Agenda
City of Springboro Planning Commission Meeting
Wednesday, April 13, 2022, 6:00 p.m.
Council Chambers, City Building, 320 West Central Avenue

Background Information & Staff Recommendation
City of Springboro Planning Commission Meeting
Wednesday, April 13, 2022, 6:00 p.m.
Council Chambers, City Building, 320 West Central Avenue

Revision to Final Development Plan, 765 West Central Avenue (SR 73), PUD, Planned Unit Development, LaComedia Dinner Theater, construction of accessory structure

Minor Revision to Approved General Plan, The Springs PUD, Planned Unit Development, revision to apartment component

LAYOUT PLAN

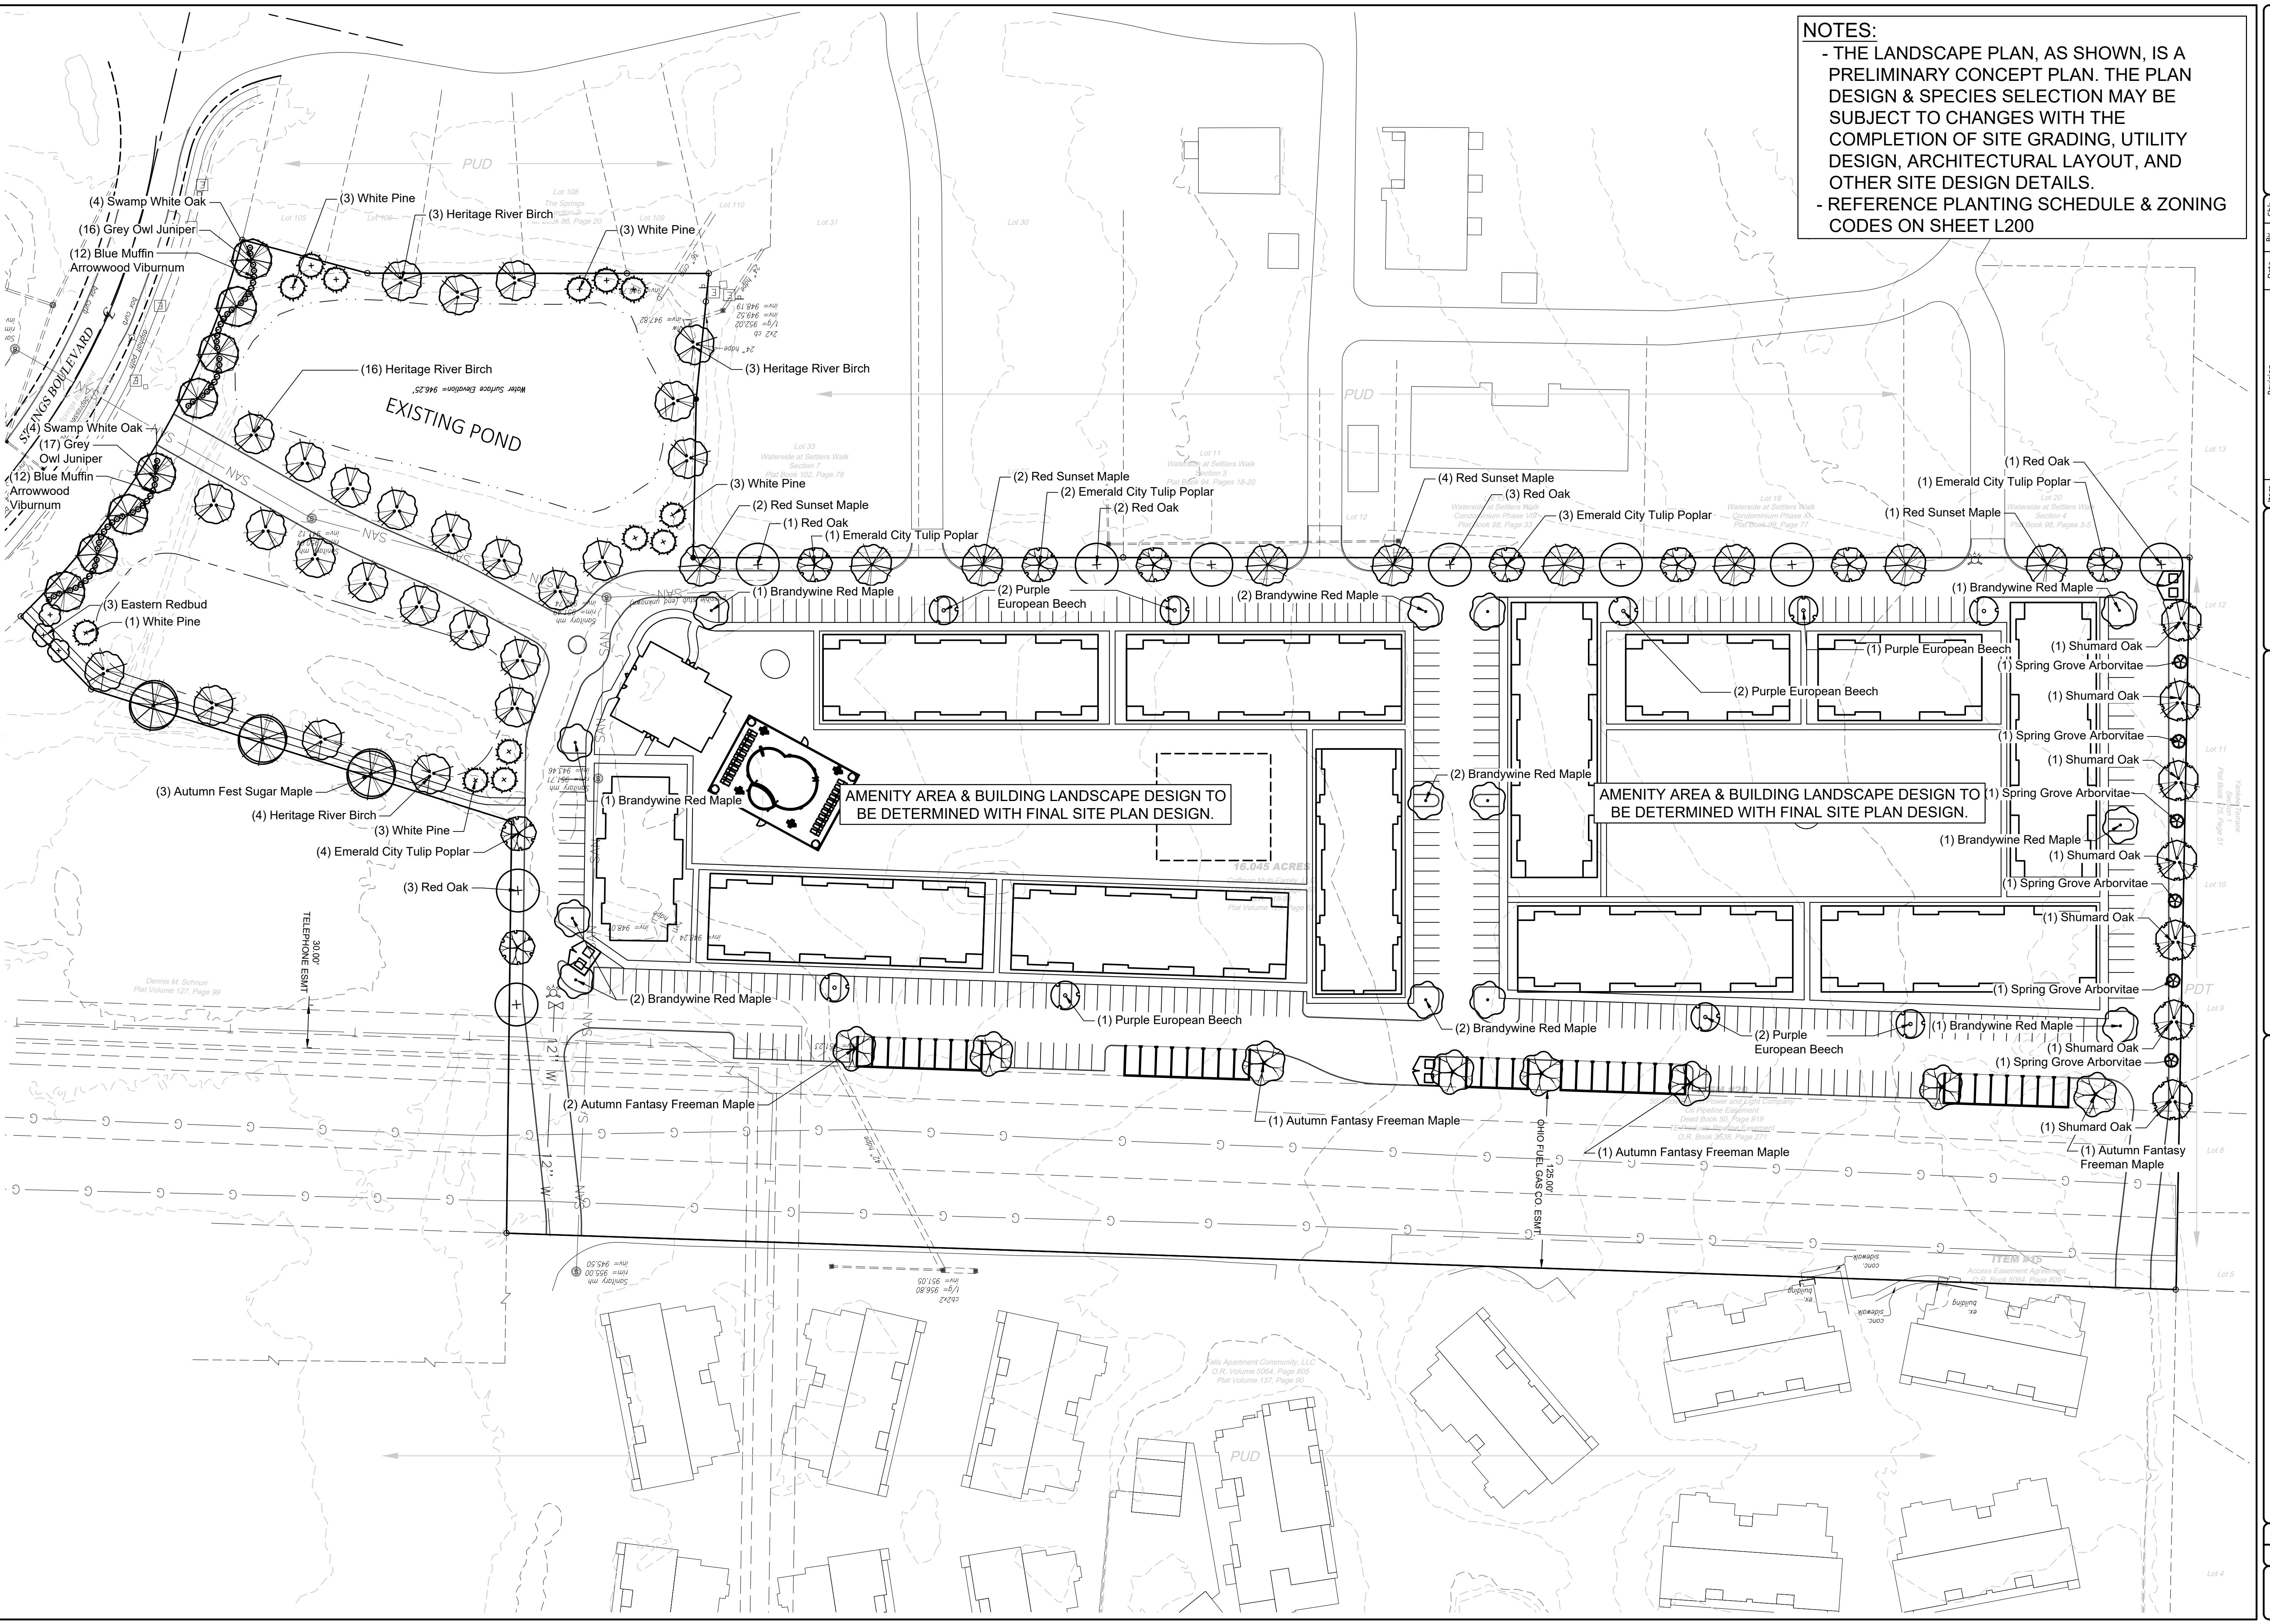
8. Provide all aspects of infrastructure design with the final development plan submittal following approval of the general plan.
9. At least two access connections shall be provided for the site. Provide approved access connections on the final development plan with documentation (e.g., a signed agreement).

10. Show the access to Springs Boulevard through to the street.
11. Provide central mailbox unit, which is to be reviewed and approved by the Springboro Post Office.
